MidPeninsula Regional Open Space Dist.
via email: Hwy17@OpenSpace.org
sent July 10, 2019

re: Comments on the Highway 17 Regional Trail Connection

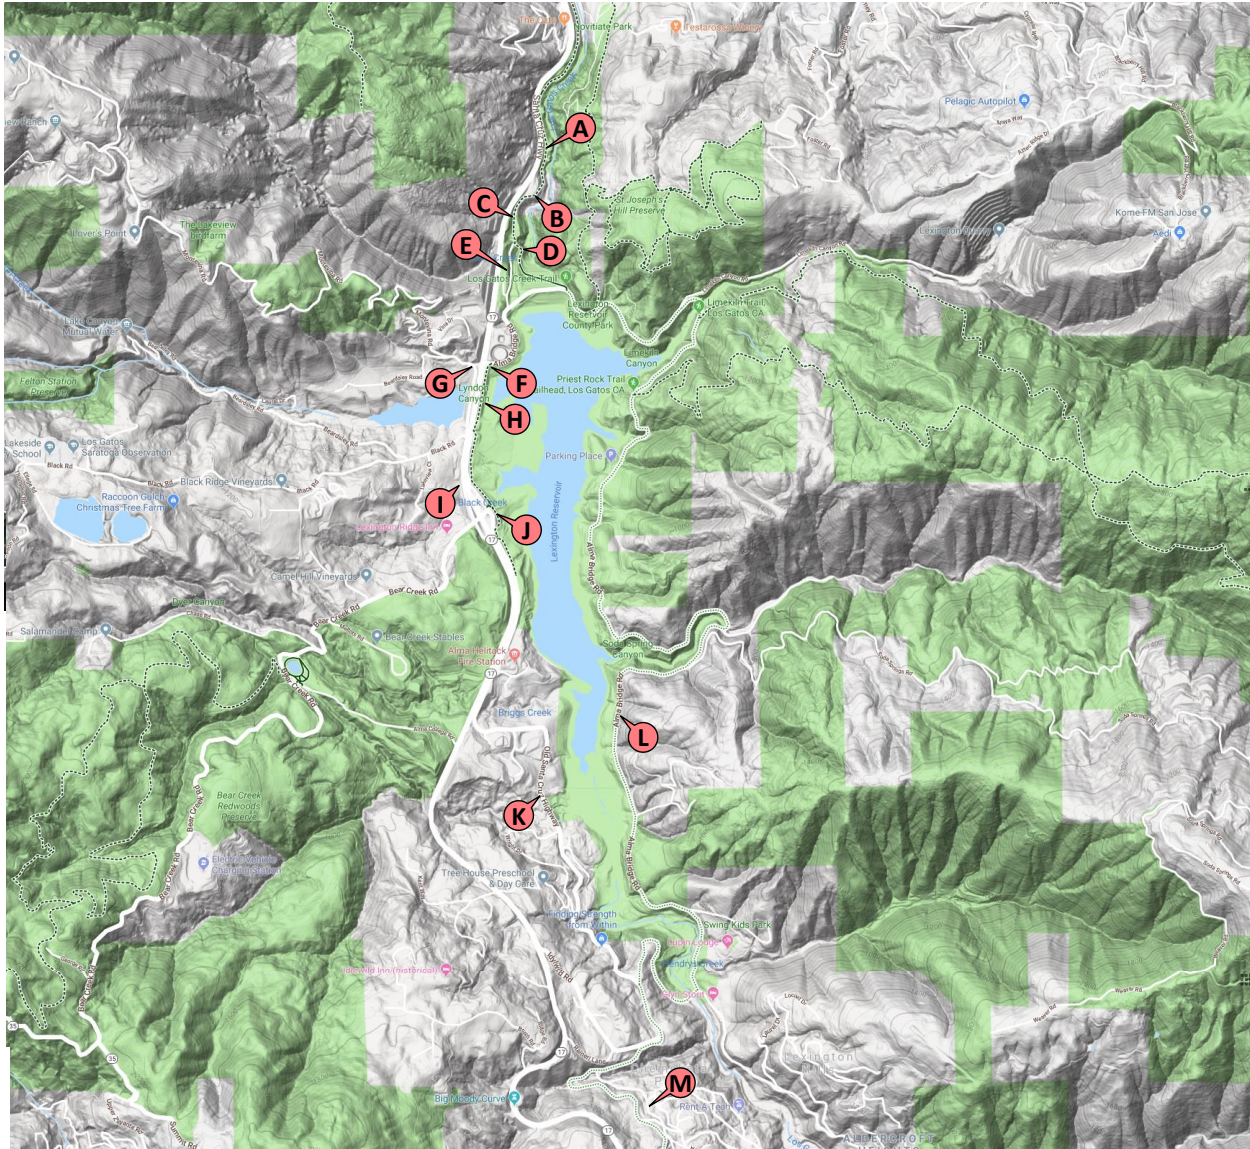
- What is the total elevation gain in connecting across the freeway? While the trail users are out for the exercise, they may still dislike having to needlessly climb down into a canyon and back up the other side, especially if another alternative would involve less climbing.
- Some of the alternatives presented involve a series of switchbacks. If the trail is to be used by bicycles, I recommend at least a 6' radius-of-curvature at the inside of the hairpin turns.
- Consider the proximity to parking: not every trail user is going to walk the entire south bay portion at once. Alternative 3 seems most convenient to the trailhead parking on Alma Bridge Road; Alternative 4 also looks viable; but Alternative 5 seems quite distant, and might discourage out-and-back day-use of the far-side portion of the trail.

- The trail on the east side of 17 ("H" on the diagram) provides a direct connection from the Los Gatos Creek Trail to Old Santa Cruz Highway ("K" and "M"), shaving roughly 25 minutes and ~100' of climbing relative to the Alma Bridge Road route on the east side of the reservoir ("L").

- The trail "H", Old Santa Cruz Highway ("K") and Alma Bridge Road ("M") make a scenic loop around the reservoir. This loop trail can be accessed from town either by the Los Gatos Creek Trail, or by driving up Hwy. 17 and then parking by the dam. And if the trail "H" could be given an all-weather surface, this would create a year-round amenity.

- If possible, it would be nice to improve the Los Gatos Creek Trail itself. Currently, south from town it follows a gentle grade on a levee "A" along the creek, then takes a very steep climb up hill "B" to reach a nearly level segment "C" along an old Hwy. 17 alignment. Is there any way to improve (regrade?) segment "B" to make it less steep?

- The trail currently dips sharply at “D”, crosses a bridge, and then climbs the face of the dam. If the old spillway path “E” could be reopened, it would be a more direct connection.

- Presently, the trail connection from Alma Bridge Road “F” at Hwy. 17 is poorly marked, and visitors and others not familiar with the alignment might have difficulty finding the through route. Alma Bridge Road itself could also be improved there for bicycle safety.

- The proposed Alternative 4 crossing would connect Alma Bridge Road at “F” to Montevina Rd at “G”, which would be nice, but is not necessary: the west-side road “I” is fairly level, wide, and quiet, so the one-mile detour from “F” to “G” via “H”, the Bear Creek crossing at “J”, and back down on “I” is not too onerous for bicyclists.

- If there is a crossing from “F” to “G”, please keep (and improve) the trail “H” anyway: it gives a nice overview of the reservoir that would be lost if one instead had to go to the other side via “F”, “G”, “I”, and “J”. Also, the two extra freeway crossings could be annoying.
